To: Zoning Board of Appeals
From: Maria Morelli / Planning Department
Date: October 22, 2015
Case: 29 Summit Avenue (BOA #2014-0028)

Re: Proposed basement garage and driveway

29 SUMMIT AVE.

Proposed Driveway and Addition Plan

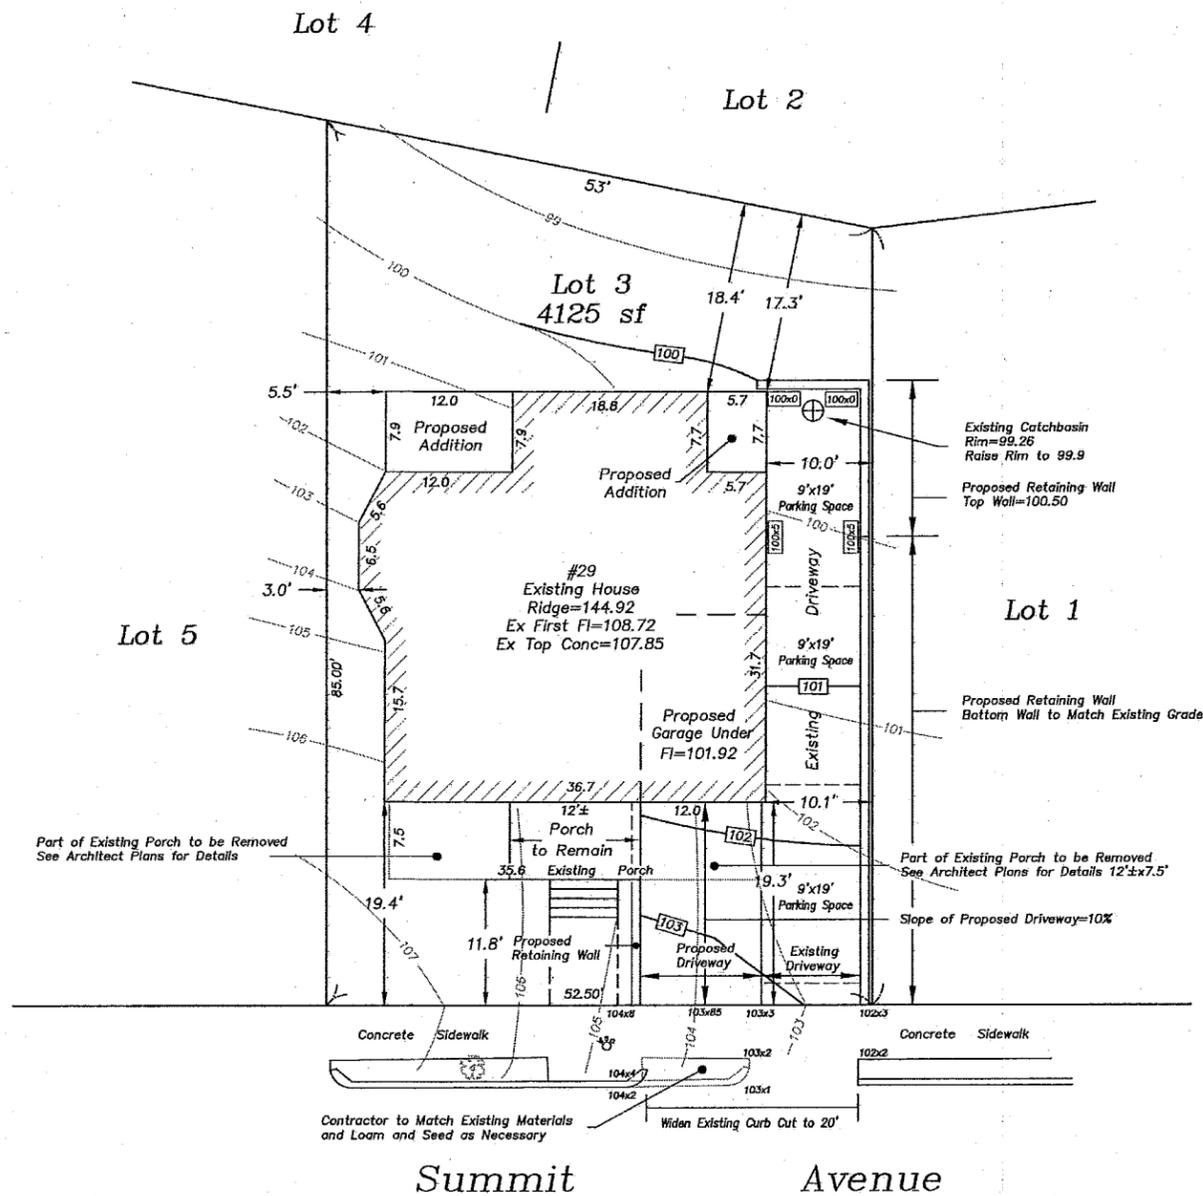
Driveway Grading: To achieve no separation in grade between the driveway and the sidewalk and accommodate a garage door height of 7 feet, as recommended by the Planning Board, the applicant would need to raise the house three to four feet. (The Planning Board was concerned that the grading of the driveway did not transition gradually to street level to ensure pedestrian safety.) The applicant's response was to raise the ceiling of the basement one foot to accommodate the 7-foot high door and to soften the grading from the street to the garage door entrance and to even the cross-slope of the two driveways. Although the slope of the driveway is 10%, and deviates from the Board's recommendation, the Planning Department considers this alternative preferable to raising the house three to four feet and notes that the slope is compliant with regulations. To address the Board's concern about pedestrian safety, the Planning Department has consulted with Peter Ditto, Director of Engineering and Transportation. He will provide his comments regarding proposed grading and any possible adjustments under separate cover.

Driveway Materials: The applicant has committed to installing pavers in the two driveways but this should be indicated on the final site plan.

The Planning Department recommends that a final site plan show the parking layout for three cars, as well as pavers indicated for the new and existing driveway.

2. Prior to the issuance of a building permit, the applicant shall submit a final landscaping plan indicating parking layout, paver materials for the driveway, and all counterbalancing amenities, subject to the review and approval of the Assistant Director for Regulatory Planning.

Proposed Elevations
Front and Right Elevations

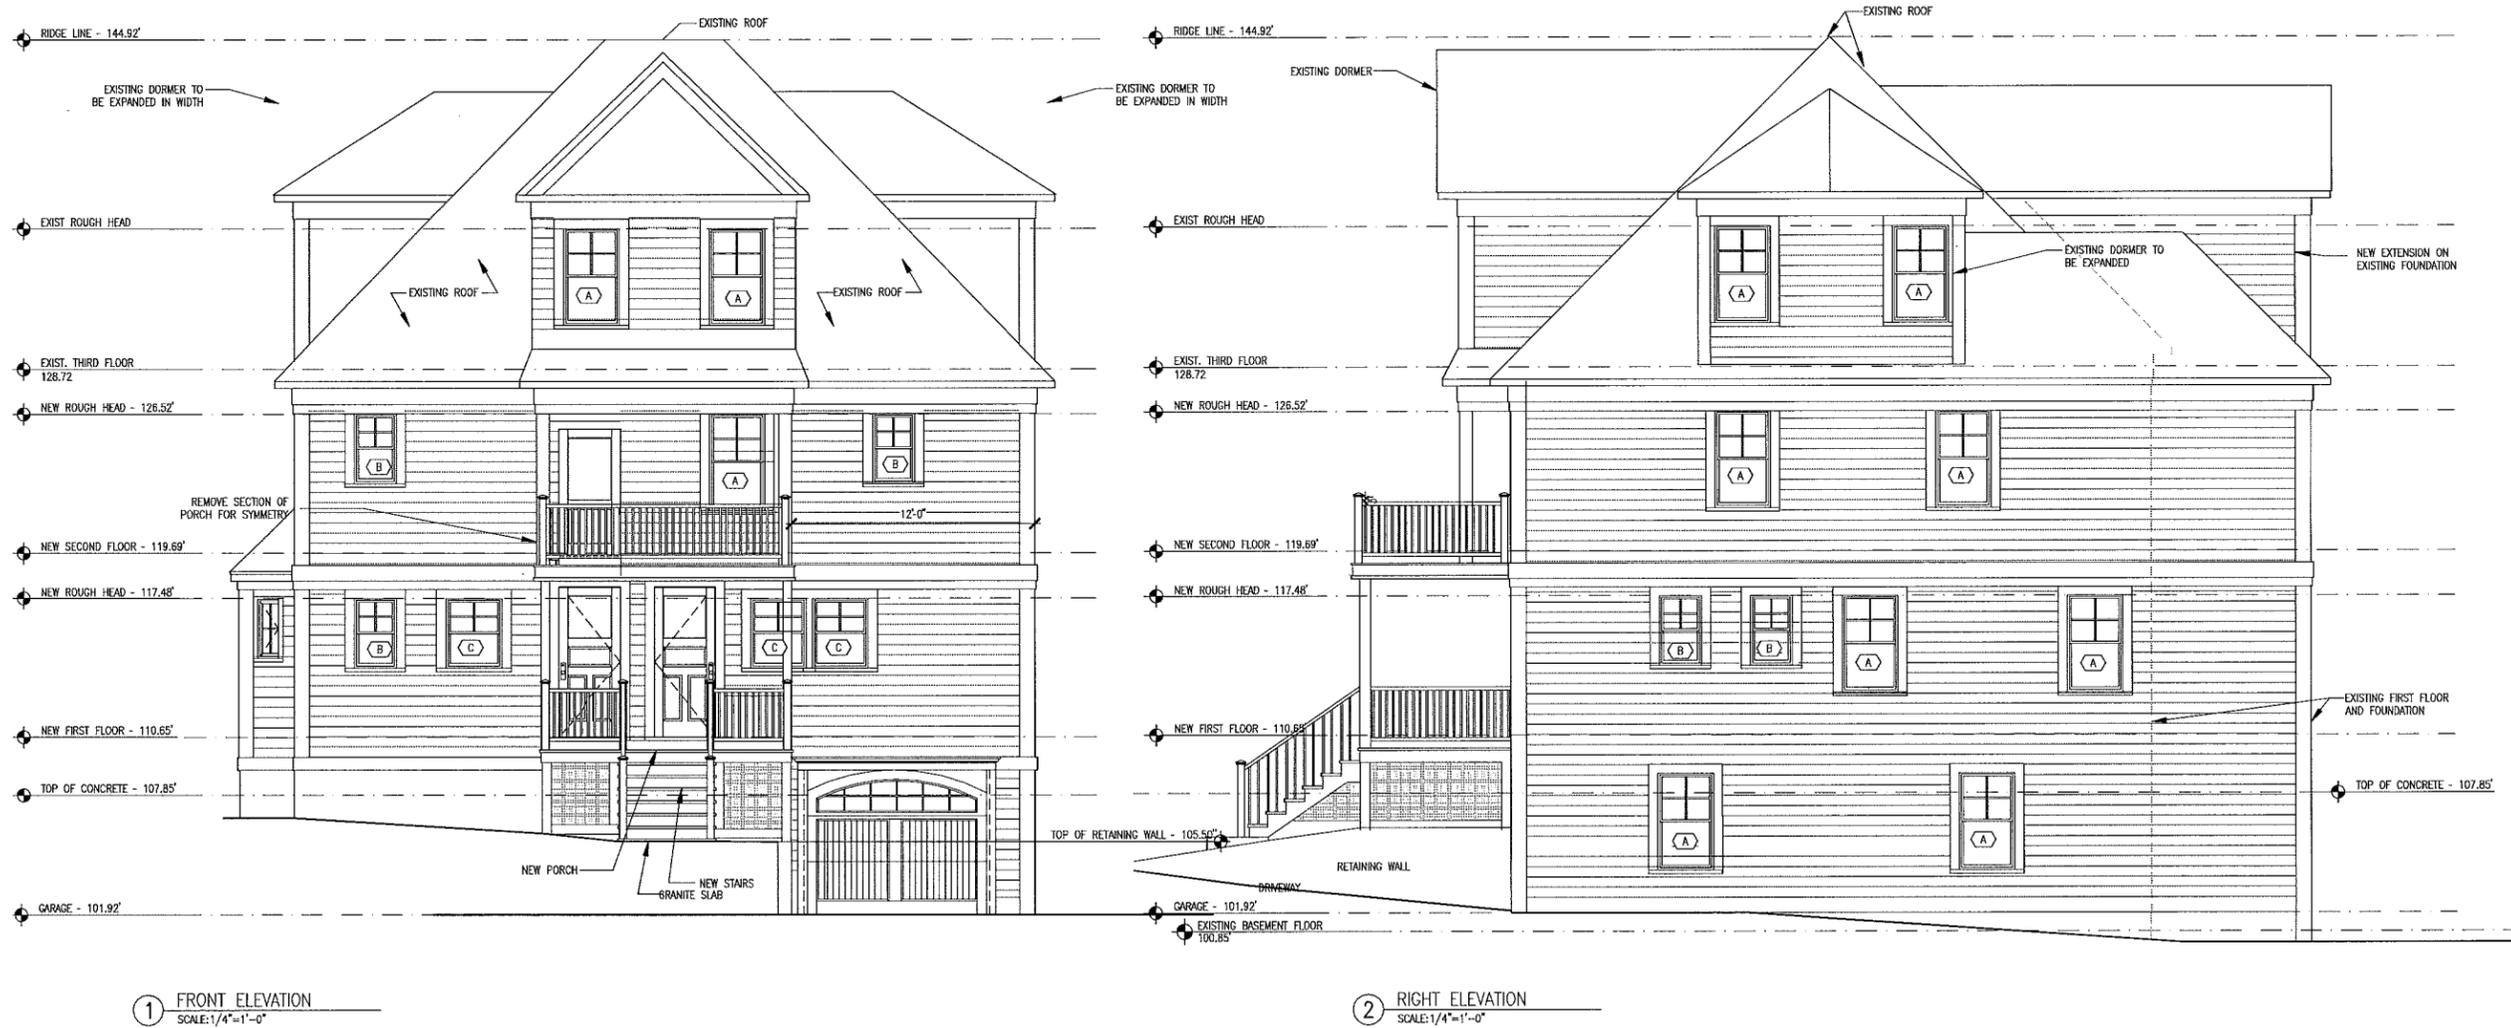
The plans have been revised to improve the unbalanced front entrance and awkward intersection of portions of the roof form. Raising the ceiling of the basement is preferable to raising the house itself to accommodate a 7-foot high garage door.
